RE: FCC ID: AFJ277602_ATCB001830

Attention: Tri Luu

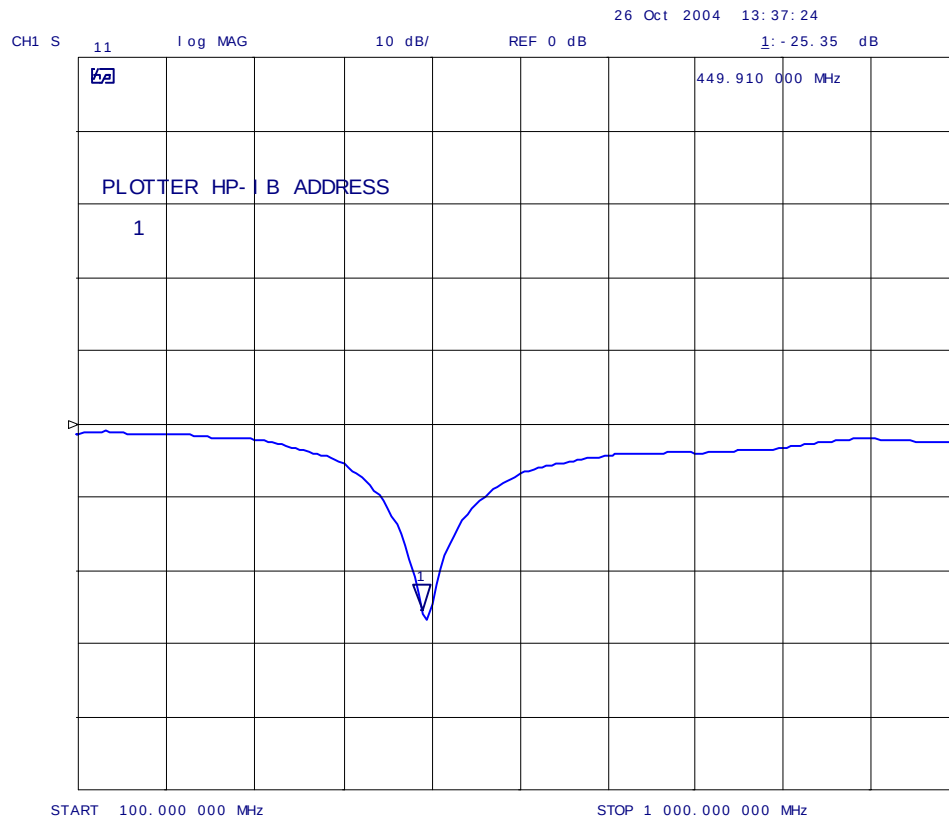
3. Please note that the accessory use statement in the manual states to use the accessories listed on page 33. However, please note that there is no page 33 of the manual and please note that the list of accessories appears to be on pages 30 and 31 of the manual. Please correct to give accurate location of data in the manual.

Pl find revised user manual attached.
